Subject: Additional Information for the Review of the License Renewal Applications for Quad Cities Nuclear Power Station, Units 1 and 2 and Dresden Nuclear Power Station, Units 2 and 3

Response to Request for Additional Information

DRESDEN AND QUAD CITIES
LICENSE RENEWAL APPLICATION
REQUEST FOR ADDITIONAL INFORMATION

Figure 1. Finite Element Model of Class 1

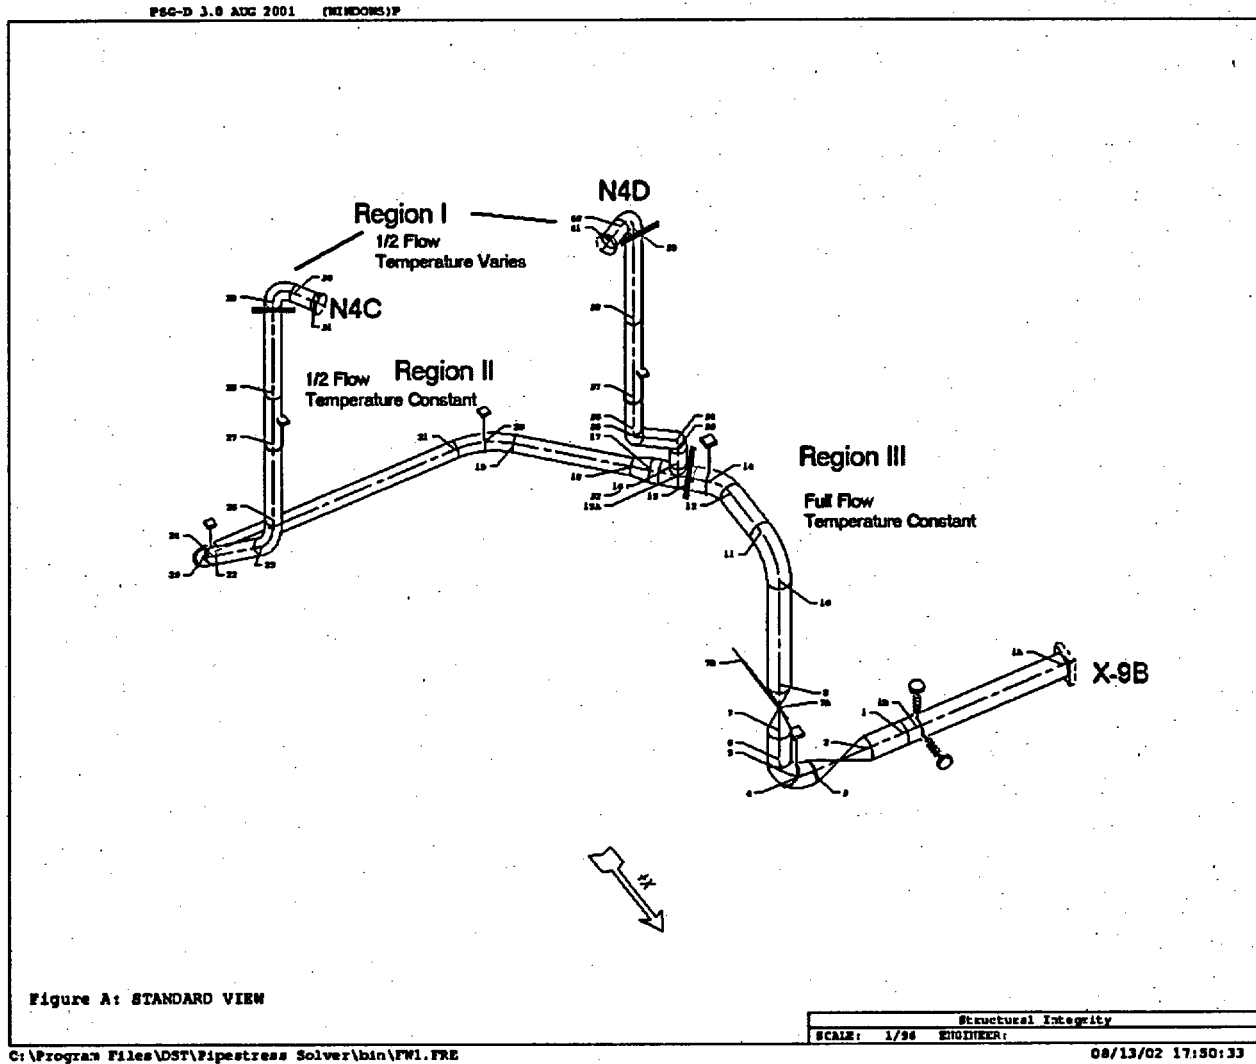
RAI 4.3.4

The disposition of this TLAA indicates that Exelon will perform plant-specific calculations for Dresden and Quad Cities for the locations identified in NUREG/CR 6260 for older BWRs, except for a limiting Class 1 location in a feedwater line. Provide the following additional information: (a) state where the limiting Class 1 feedwater piping location will be identified; and (b) provide the calculated cumulative usage factors for these locations.

- (b) Review of the B31.1 stress reports for all four Dresden/Quad Cities units was performed and the bounding geometry from all eight feedwater loops (2 loops per unit, four units) was selected for modeling. The results of the fatigue analysis determined that the location with the highest fatigue usage ($U = 0.0859$) was at the tee joining the N4D riser pipe to the header (Node 15A), as shown in Figure 1. This limiting location will be used to perform plant-specific environmental fatigue calculations. Note that this selection excludes the reactor pressure feedwater nozzle location, because that location will be separately evaluated for environmental effects as was done in NUREG/CR-6260.
